Class I modifications for quarter ending September 30, 2009

**Hanford Facility RCRA Permit Modification Notification Forms**

**Permit Revision 8C  
Hanford Facility RCRA Permit**

<b>Hanford Facility RCRA Permit Modification Notification Form</b>				
Unit: <b>Permit Revision 8C</b>	Permit Part & Chapter: <b>Hanford Facility RCRA Permit</b>			
<u>Description of Modification:</u> Permit Introduction				
<b>Introduction</b>				
<p>Where information regarding treatment, management, and disposal of the radioactive source, byproduct material, special nuclear material (as defined by the Atomic Energy Act of 1954, as amended) and/or the radionuclide component of mixed waste has been incorporated into this permit, it is not incorporated for the purpose of regulating the radiation hazards of such components under the authority of this permit or Chapter 70.105 RCW.</p> <p>Pursuant to Chapter 70.105 RCW, the Hazardous Waste Management Act (HWMA) of 1976, as amended, Chapter 70.105D RCW, the Model Toxics Control Act (MTCA), and regulations promulgated there under by the Washington State Department of Ecology (hereafter called Ecology), codified in Chapter 173-303 Washington Administrative Cod

24590-HLW-PCN-ENV-09-001

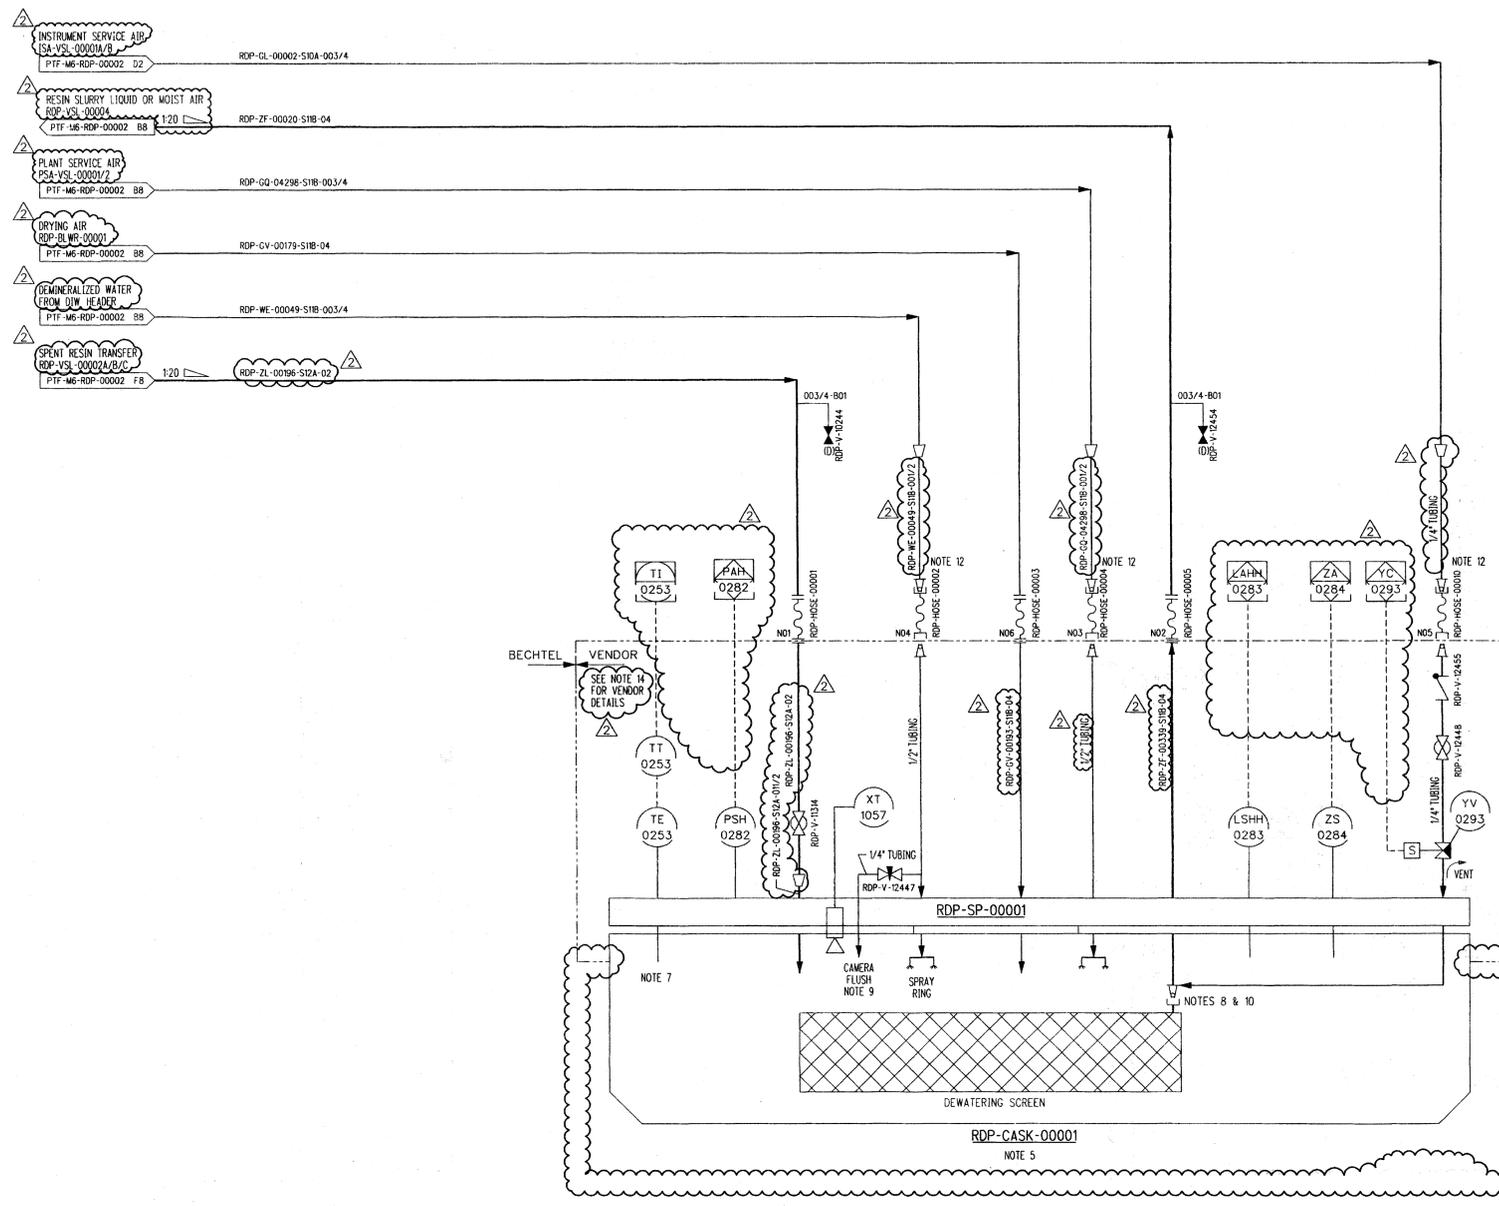
- Modified, deleted, and added notes, holds, and references
- Modified, identified, and added support/utility system lines, valves, in-line components, instruments and logic controls
- Incorporated changes from change documents identified in the final note on each P&ID
- Drawings converted from a single sheet to multi-sheet drawings
- Revised, identified, and added slope symbols and/or the slope requirement
- Replaced steam ejector with steam heating sparger on drawings 24590-PTF-M6-UFP-00002001, Revision 0 and 24590-PTF-M6-UFP-00003001, Revision 0

- Ultrafilter (UFP-FILT-00004A) added to drawing 24590-PTF-M6-UFP-00002004 as part of External Flow Sheet Review Team (EFRT) recommendation
- Ultrafilter (UFP-FILT-00005A) added to drawing 24590-PTF-M6-UFP-00002005 as part of EFRT recommendation
- Added in-line component heat exchanger UFP-HX-00001A to drawing 24590-PTF-M6-UFP-00002005
- Ultrafilter (UFP-FILT-00004B) added to drawing 24590-PTF-M6-UFP-00003004 as part of EFRT recommendation
- Ultrafilter (UFP-FILT-00005B) added to drawing 24590-PTF-M6-UFP-00003005 as part of EFRT recommendation
- Added in-line component heat exchanger UFP-HX-00001B to drawing 24590-PTF-M6-UFP-00003005
